SUBJECT: Improvements to the electromechanical wheel clamping system

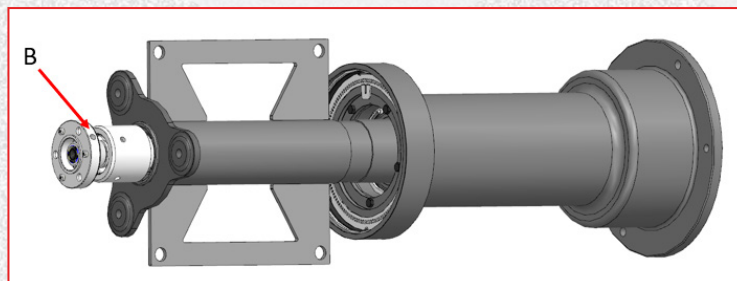
1. The hexagon head clutch fixing screw VTE 5739 8.8 BR M 3X 12 code 2-00690 (A in the figure) has been replaced by the new cylindrical head hexagon socket **screw** VTCEI 4762 12.9 BR M 3X 12 **code 2-00922**.

2. The optical rotary encoder "codewheel" (B in the figure) code 4-116965 has been replaced by the new **codewheel code 5-126995**.

NB: tighten to 1Nm and use LOCTITE 243 threadlocker.

The new screw ensures greater resistance to fatigue.

The new component ensures better reflectance and greater resistance to moisture.
